REQUEST FOR INFORMATION FORM  
PERRIS VALLEY - BIG LEAGUE DREAMS

M.I.G., Inc.  
801 N. Harbor Blvd. Fullerton, CA 92831  
Attention: Robert Echavarría - Project Manager  
FAX: (714) 871-1188

CONTRACTOR: W.F. O'neal Construction

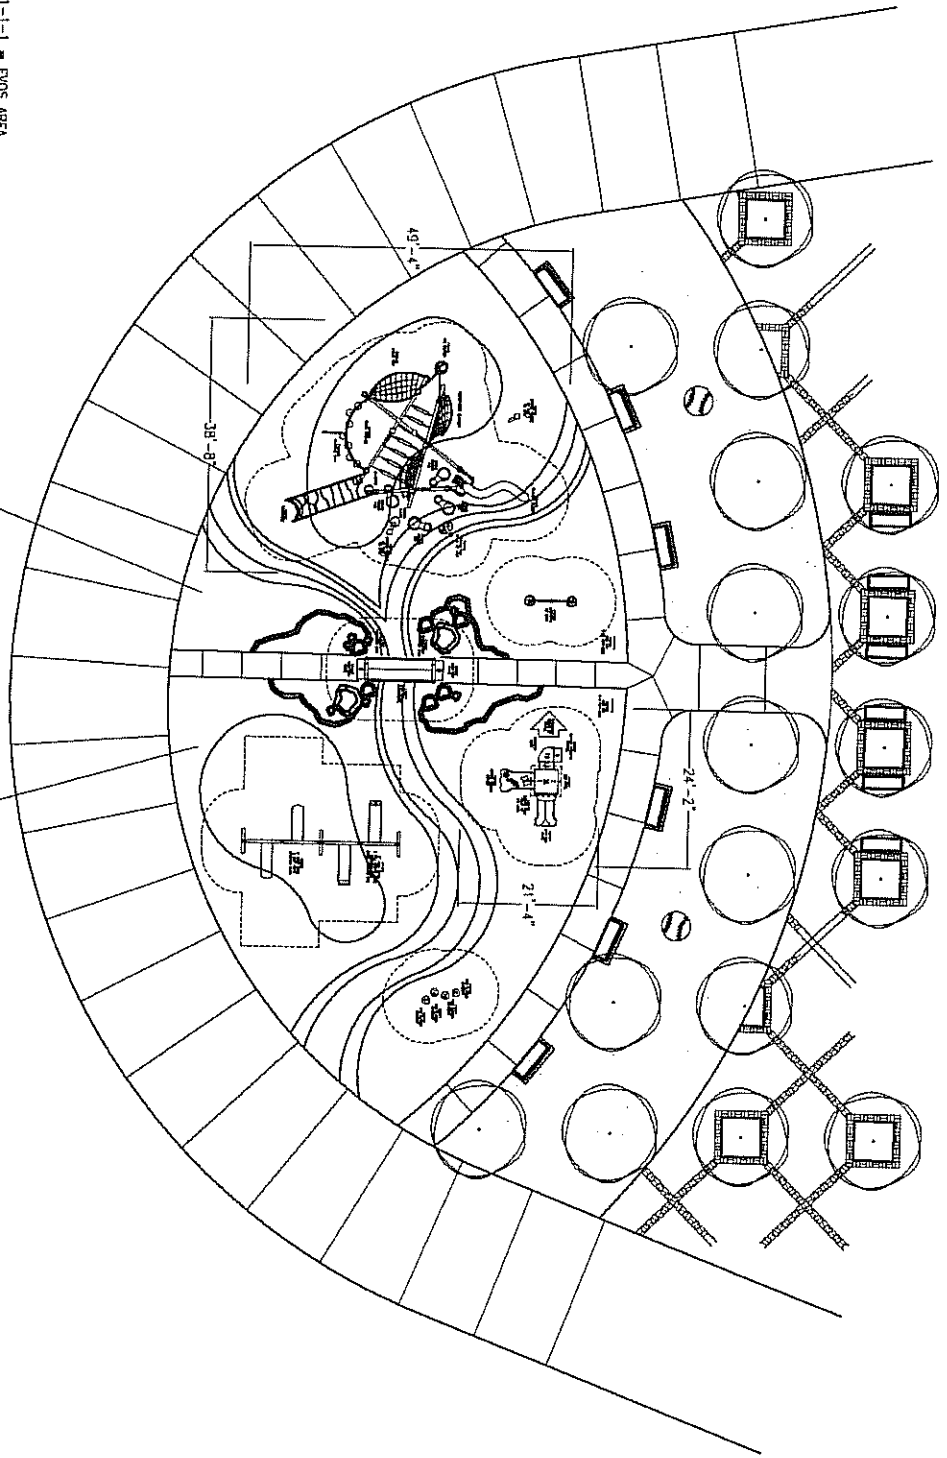
**Question** Date Required: 3/19/2010

The plans and specifications do not seem to include the playground equipment designs showing the activities used on the structures.

In the specifications for the playground equipment it refers to plan sheet LM-1 and LM-2 which only shows the manufacturer of the product, model number and contact information. On plan sheet L1.2 it references sheet LD-1.4 for the playground enlargement. LD-1.4 shows the top view of the equipment and details for the rubberized surfacing but does not show the activities on the playground equipment.

To provide pricing for an equal product the Contractor would need a detailed copy of the playground equipment top view with all the activities shown and labeled.

Please provide detailed equipment plans and specifications of all components required.

Is the equipment on LM-1, Landscape Structures by Coast Recreation the only play equipment that is acceptable?

To reiterate RFI #4:  
Per the General Conditions section 5.3 Substitutions and Spec Section 01600, 1.9-Substitutions, the burden of proof as to the comparative or suitability of the offered materials, articles or equipment shall be upon the Contractor.
